SUBJECT: 100 KING STREET
BAR CASE # 2013-00124

Update Since the Previous Hearing

100 King Street, Alexandria, VA
Exterior Presentation - Awnings

Docket Item # 4
BAR CASE # 2014- 00124

Proposed Perspective

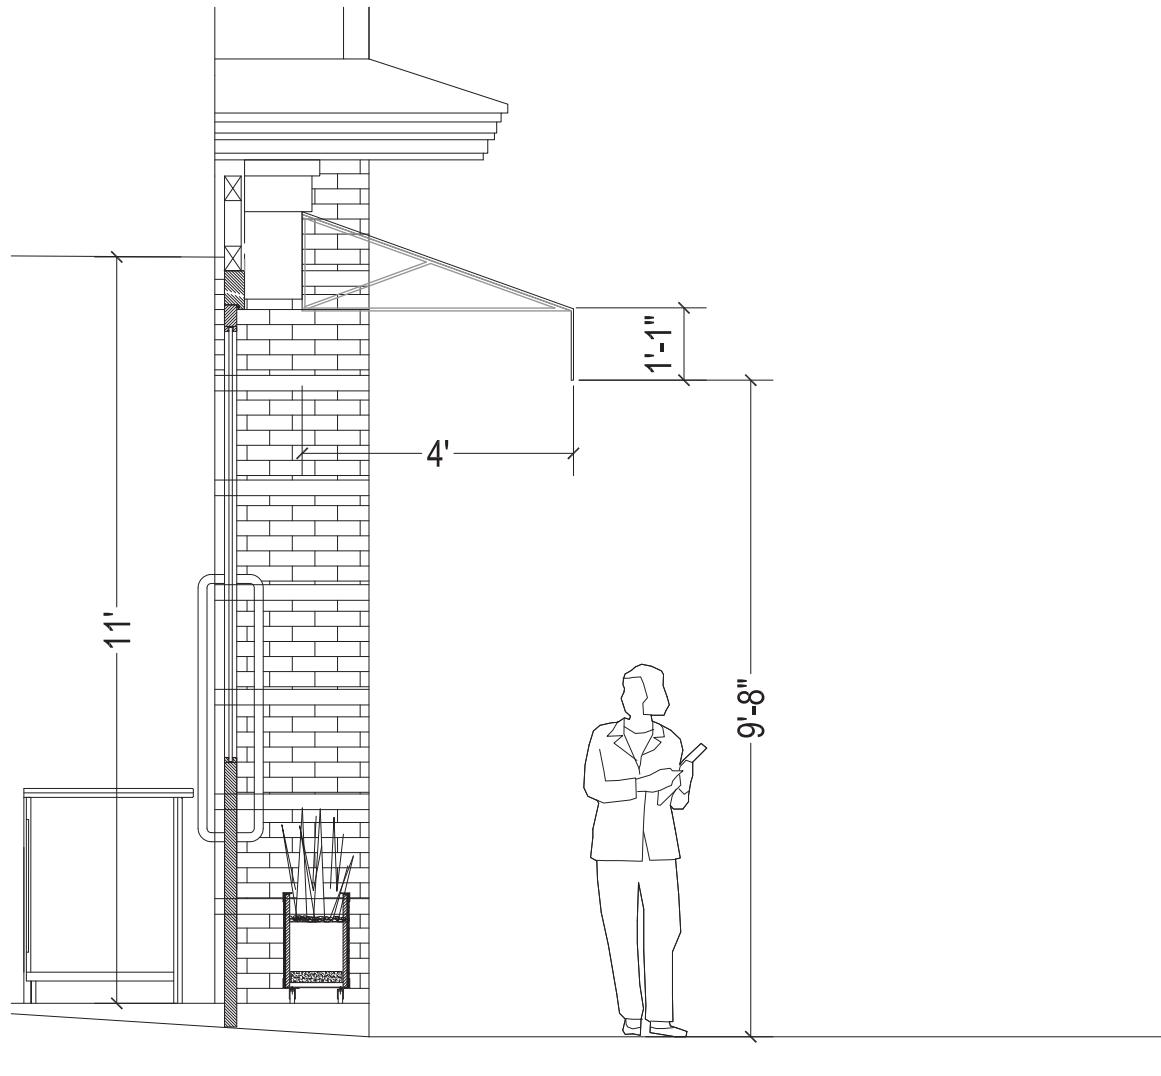
The applicant has responded to the Board's request for a more delicate awning that does not create an overabundance of signage and detract from or block views of the historic architecture. Staff finds that the proposed simplified awnings comply with the *Design Guidelines* and will complement the previously approved hanging signs and menu boards. Staff recommends that the

loose valance on the awnings not exceed 10" tall, as was approved at Landini's Restaurant across the street, rather than the 13" height proposed. There was substantial discussion about the size and design of the awnings at the recent Landini's hearing and 10", rather than 13", is actually much closer to the scale of the valance represented in the Carluccio's color rendering.

1. That the awning valance not exceed 10" in height; and,
2. The center flag at the corner be deleted and its wall mount removed.

Proposed Union Street Side Elevation

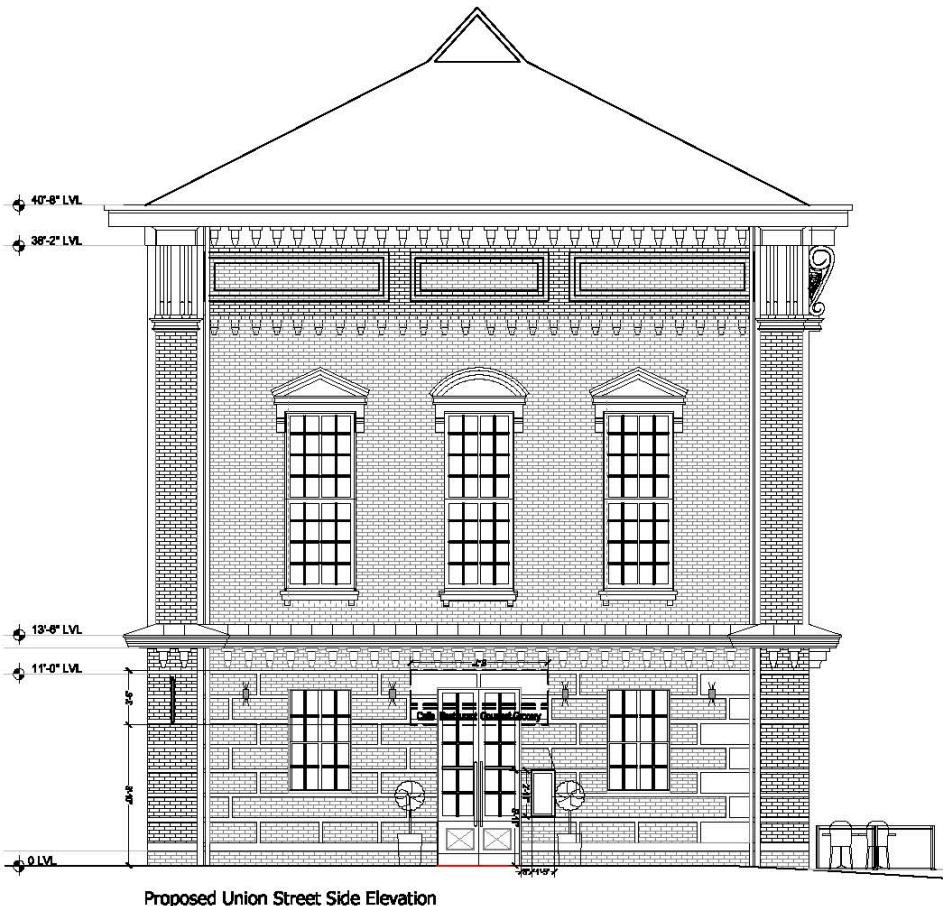
Ms. Roberts said that she thought the awning along Union Street would intrude on the sidewalk too much and that, overall, she felt that the awnings obscured the building architecture.

Mr. von Senden said that the awning proposed for Union Street was over-scaled and agreed with Dr. Fitzgerald that fixed awnings with a delicate frame would be preferable to retractable awnings. He suggested that the awnings be installed below the dentil work of the storefront cornice on this high style building. He said that he initially had concerns about the relocation of the granite sill course but after speaking with Staff he understood the reasoning behind the proposal.

Staff has no objection to the proposed planters on the King Street elevation. However the proposed planters on S. Union Street will crowd the busy, narrow public sidewalk and are not supported by staff. Portable planters, such as these, are not typically reviewed by the BAR, though permanent planters within the public right-of-way require BAR approval, a building permit and an encroachment ordinance.

3. That the awning on S. Union Street be deleted or, if the BAR approves an awning in this location, that the fabric ends of the awning be eliminated and the special advertising sign text at the valance of the awning be eliminated or replaced with the name Carluccio's;

8. That the granite step for the new entrance be preserved in situ and the sidewalk brick warped to provide handicap access;
9. That the planters on the S. Union Street elevation be deleted, and;

2 x exterior projecting signs on proposed King Street elevation
1 x exterior projecting sign on proposed Union Street elevation

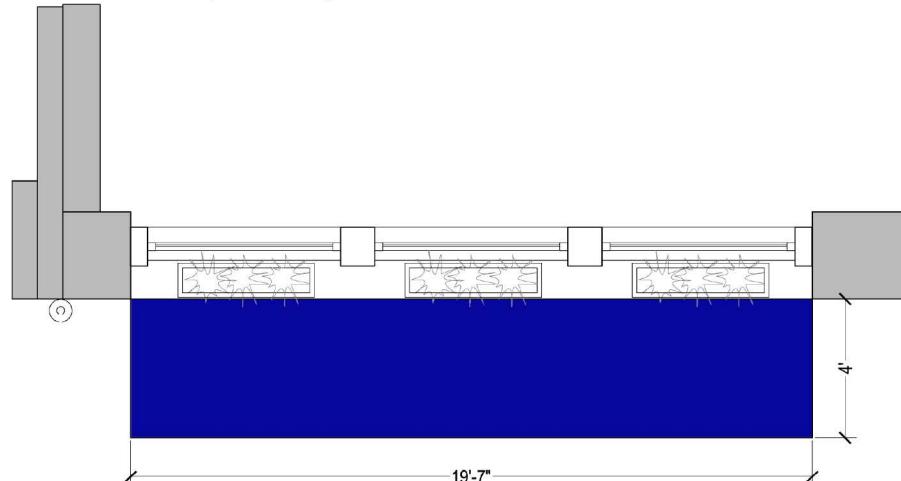
Staff finds the two proposed hanging signs on the King Street elevation redundant and their placement nonfunctional, as they are largely obscured by the proposed awnings, preventing optimal visibility from all directions. Staff therefore recommends that only one sign be approved and that it be located at a 45 degree angle on the northeast corner if the building so that it is plainly visible from both King and Union streets. The businesses directly across the street – the Lucky Knot and Starbucks – have both successfully implemented this type of corner sign. Staff notes that any hanging sign at this location should not be internally illuminated, as the Board has repeatedly stated that internal illumination is inappropriate for signs placed on historic buildings and that these should be externally illuminated. Staff recommends that the Board maintain this position for this historic structure.

- The proposed hanging signs on King Street are located 7'10" above the sidewalk, 8' clearance is required. Reduce the sign dimension or move the sign higher.
- The sign on the valance of the center awning is special advertising and is not permitted.

1. That only one hanging sign is approved in a location at the northeast corner of the building with the bottom edge at least 8' above grade and externally illuminated;
2. That the awnings on the King Street (north) elevation be deleted or, if the BAR approves awnings in this location, that the fabric ends of the awnings be eliminated, that the special advertising sign text be eliminated and the Carluccio's name printed on only the center awning's valance;

DETAILS OF THE PROPOSED FIXED AWNINGS

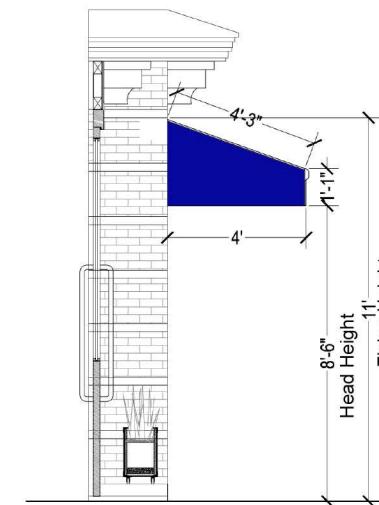
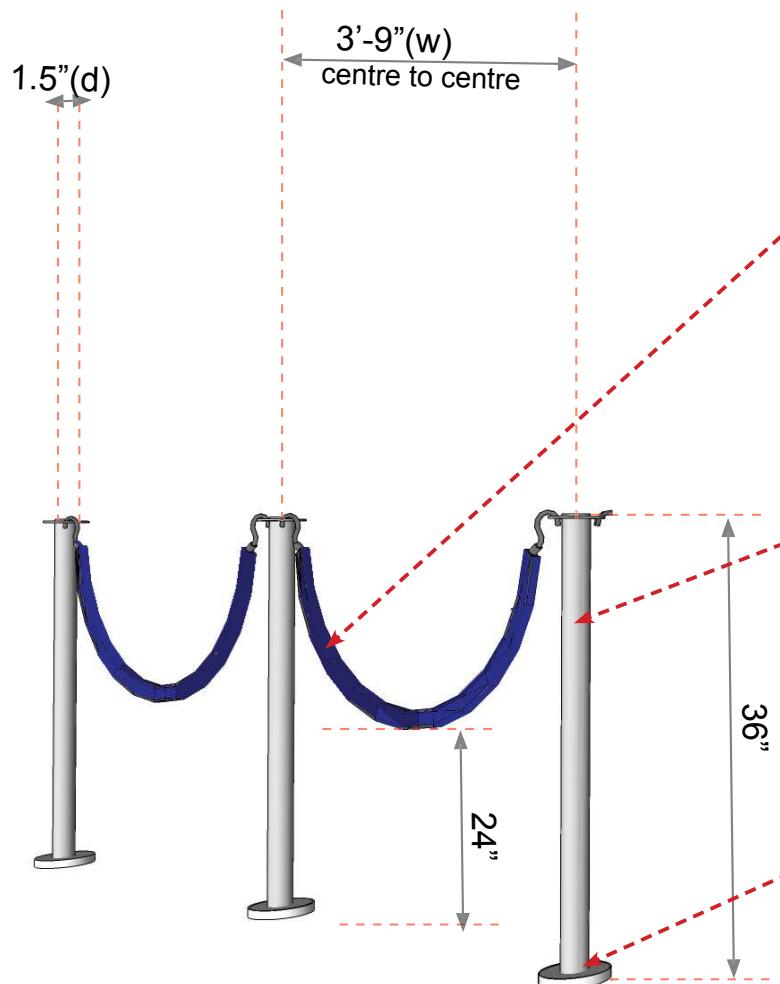
Staff finds that the proposed awnings, in particular, detract from the pedestrian’s view of the architectural details on the lower level cornice and serve no functional purpose other than advertising, as they are located on a northern elevation that does not receive substantial sun and is consistently shaded by the adjacent tall buildings. Furthermore, the Design Guidelines state that awnings should “play a secondary role and augment, not compete with the architecture of a historic building”.

However, the Board has recently approved simple awnings at nearby business, including Landini’s (historic structure) and Coco Blanca (a contemporary building). In both of these cases, the Board asked that the fabric ends of the awning be deleted to expose more of the building wall

to pedestrians and that the company logo be placed only on the valance of the center awning. An excellent example of this type of awning, on the Carluccio's restaurant in London, is shown in the lower left corner of page 17 of the application materials. If the Board finds awnings appropriate in this location, staff recommends that the awnings be re-designed without the fabric ends and that the Carluccio's name be located on the center valance only. The wording: Caffe Restaurant Gourmet Grocery" shown on the valance of two awnings is considered "special advertising" by the Alexandria zoning ordinance and is not permitted.
